INDESIT company

Model type:
MT246

Commercial code:
F028993

Notices

0513230: SEALS FOR DOORS FOAMED AS ONE PIECE

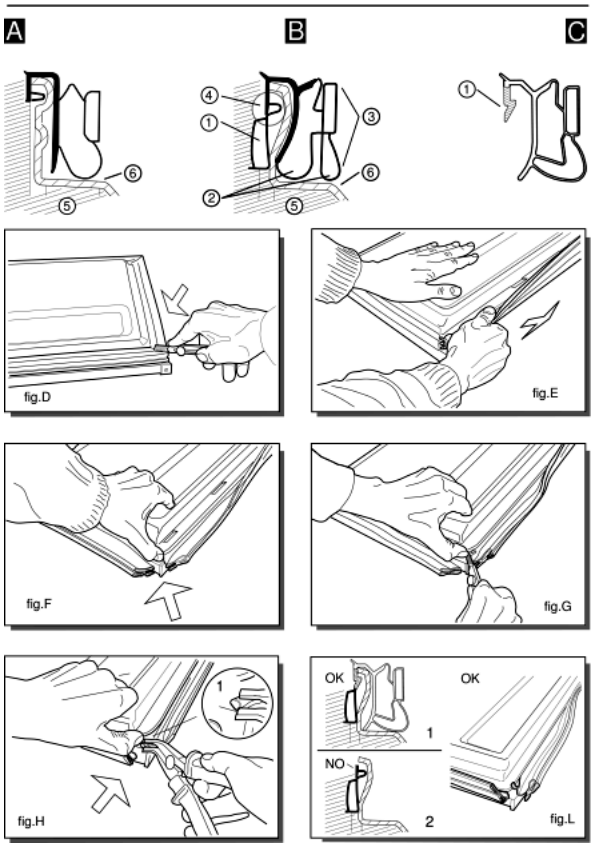
Various types of gaskets with different profile, as shown in figures (A) and (B), are used to fix the door (fig. A-5; B-5) and the inner door (fig. A-6; B-6) on the block foamed doors of combined freezers and refrigerators.
---Ilpea profile 245; 179; 412 (fig.A)
---Ilpea profile 287 (fig.B)
When replacing gaskets with profiles 245; 179; 412 these are fixed with screws (2 per corner) to the door.
Gaskets with profile 287 can not be used as spare parts but are designed to house the Ilpea type 900 gaskets (see figure C).
When replacing the gasket (287), once it is removed you will find a pocket (fig. B-1) between the door and inner door.
The rigid tooth (fig.C-1) of the gasket (900) is inserted inside between the pocket and the inner door, doing away with the need for screws.
Gasket with profile 287 is easy to identify since it has an exterior double edge (fig.B-2) which acts as a cushion when the door is closed.

To replace this gasket, follow these steps:
---Dismount the door and cut the four corners of the gasket along the joint (fig.D);
---lift the gasket and pull it carefully along its full length without tearing it (fig.E).
The purpose here is to detach the inner door slightly from the foam along the exterior edge for a depth equal to that of the gasket (fig.B-3);
---lift the corner of the inner door slightly, prising it up with your thumb (fig.F). Do not use a tool which might break the inner door;
---continue cutting the gasket inside the inner door for about 6 mm (fig.G);
---push in the tip of the pliers (type USAG N131) and pull outwards until you see the top edge of the pocket (fig. B-4) which is empty (fig.H-1);
---if you carry out this operation correctly (fig.L) you will be able to pull off the top edge of the pocket for the full length of the door.
If the gasket tears before the top edge (fig. L-2) you should repeat this operation from the other corner of the door.

---once the gasket (287), has been removed the space above the pocket (fig. L-1) can house the rigid tooth (fig. C-1) of the gasket 900.
When you fit this gasket ensure that it lies flush against the edge for the full length of the door.
If the rigid tooth is difficult to fit, eliminate any residues of foam between the door and the inner door in the gasket area.
fig.5131549A

n1025158: New central hinge for Ariston-55 2-door 240 litre refrigerators (Carinaro).

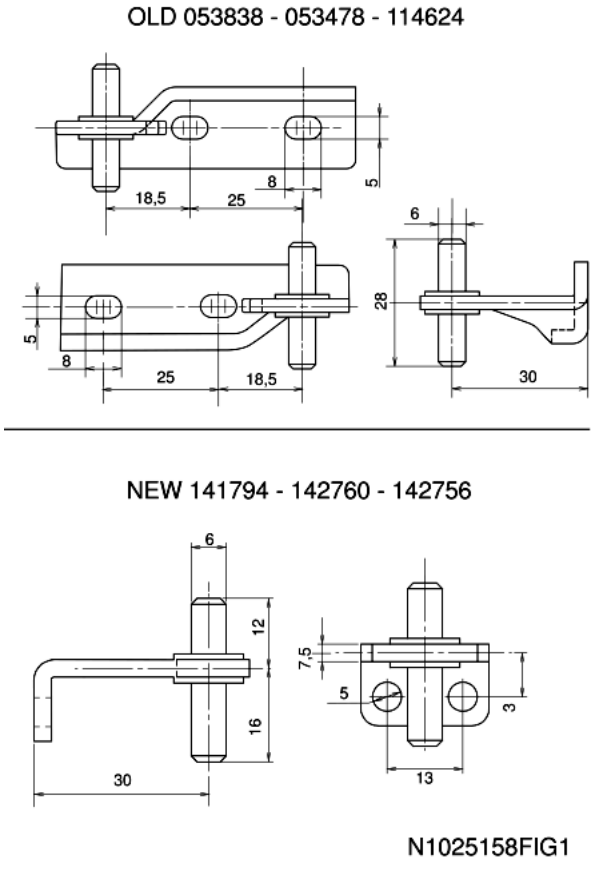
From serial no. 60123.0001, the Carinaro factory has modified the body of 240 litre refrigerators by introducing a new central hinge (see figure N1025058 Fig.1) attached to the side panel.
This hinge is still reversible but cannot be fitted on premodification models where the hinge was attached to the central trim of the refrigerator body (see Figure N1025058fig2).
When changing the door opening from right to left, the new hinge does not need to be inverted like the previous one, just moved to the left side.
To secure it, a hole must be made on the left side of the refrigerator body (see figure N1025058fig3).

141794 - POLAR WHITE CENTRAL HINGE (CARINARO)
142756 - POLAR WHITE CENTRAL HINGE (MANISA)
142756 - CHROME-PLATED CENTRAL HINGE

053838 - CHROME-PLATED CENTRAL HINGE
053478 - WHITE CENTRAL HINGE
114624 - POLAR WHITE CENTRAL HINGE
